### **Written submission from Northwatch**

Application for a licence to construct one BWRX-300 reactor at the Darlington New Nuclear Project Site (DNNP)

#### **Commission Public Hearing Part-2**

Northwatch Comments  
on Ontario Power  
Generation Inc.'s  
Application for a  
Licence to Construct  
BWRX-300 reactor(s) at  
Darlington Nuclear  
Generating Station

Figure 5: An Artist Rendition of a Potential BWRX-300 Layout

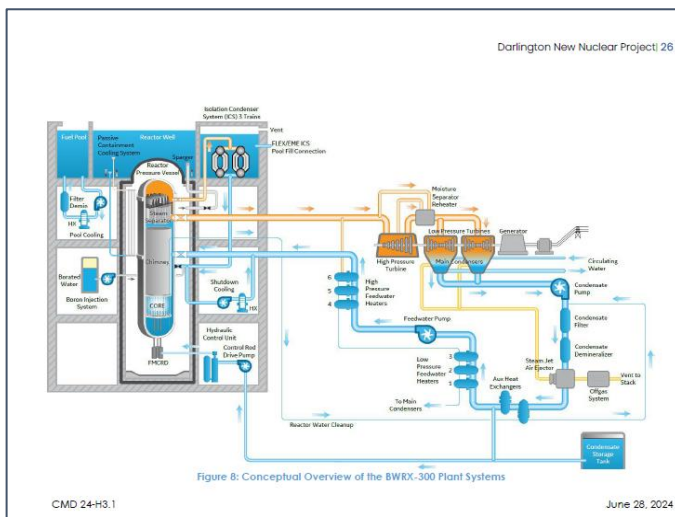
Figure 5 in OPG’s CMD is the most “readable” of the graphic presentations and identifies two features of the BWRX layout related to nuclear waste and its management: the “Radwaste Building” and the “Proposed Spent Fuel Storage” (but not the “Fuel Pool”). Figure 8 identifies the “Fuel Pool”, but not the Radwaste Building or Proposed Spent Fuel Storage.

OPG’s application very generically describes the Radwaste Building (RWB) as “housing equipment associated with the handling, processing, and packaging of solid and liquid radioactive waste generated by the nuclear facility”<sup>8</sup>. The description of the Radioactive Waste Building Structure is similarly limited. The description of the actual structure is as follows: *Its structure consists of reinforced concrete walls and floor slabs supported on a shallow reinforced concrete mat foundation with roof joists and composite roof decking. The lateral force resisting system of the structure consists of concrete shear walls, concrete floors, and a composite roof deck acting as a diaphragm.*<sup>9</sup>

As summarized above, the Application provides no description of those aspects of the building most related to its function as the location of radioactive wastes, such as shielding, robustness from extreme weather or malevolent acts, or the design and security of the actual waste containers being housed.

REQUEST: That the Commission deny the application to construct on the basis of OPG having provided inadequate information about their reactor design, including the design, design features and design basis for those parts of the site layout related to radioactive waste and its containment, including the Radwaste Building, the Spent Fuel Storage and the Fuel Pool

Figure 1: OPG CMD page 38

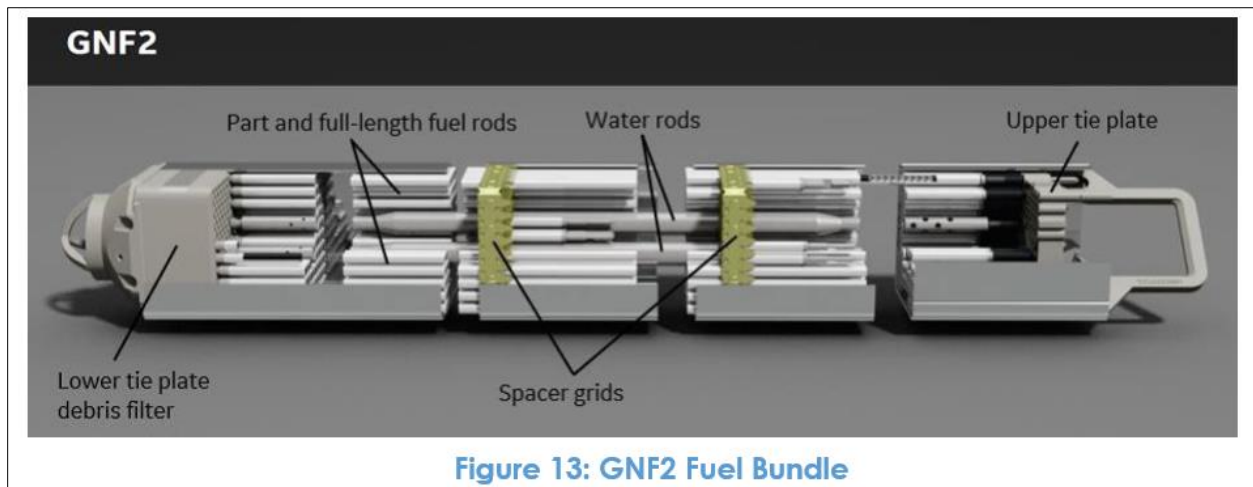
While Section 2.2 of the CMD includes a brief description of the fuel, the fuel assembly and the fuel cycle, there is no description of this same fuel after it has been irradiated and become high-level nuclear waste, or of the management structures that must be constructed – under this license application – to house the resulting waste.

Figure 4: Detailed view of Preliminary Layout of Single BWRX 300 Unit

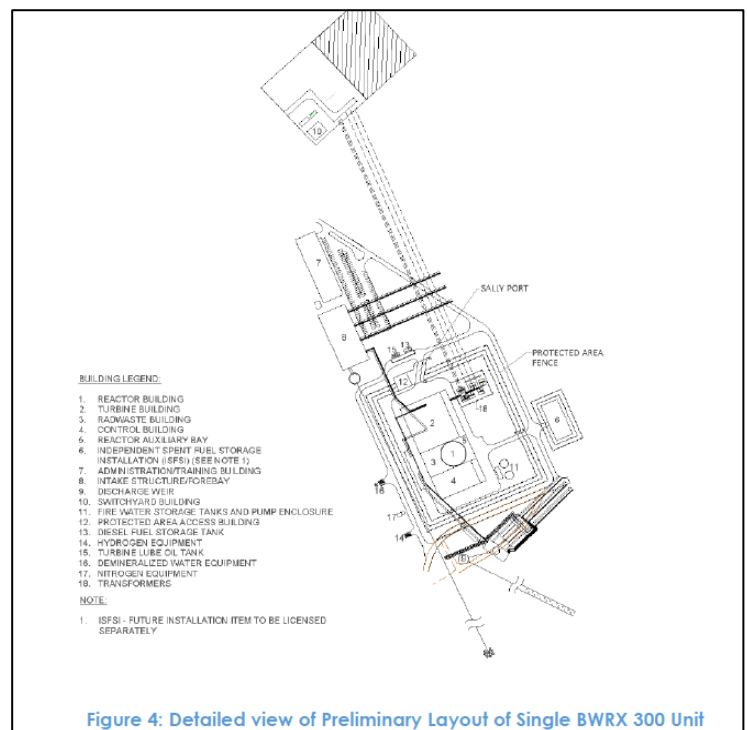
OPG claims in their CMD that “the dry fuel storage practices will reflect the fundamental safety aspects related to criticality, radiation exposure, heat control, containment and retrievability” but has provided no information or evidence to support that claim. Moreover, it appears in Figure 4 in CMD 24-H3.1 that the (future) used fuel storage facility is outside the protected area.

**REQUEST:** That the Commission defer further consideration of the application to construct until such time as OPG has submitted addressed the gaps and deficiencies in their application with respect to radioactive waste management and its facilities, including the design details of those facilities which will

be constructed prior to operation commencing, and adjustment of the site configuration to correct the current placement of the future fuel waste storage being outside the protected area.
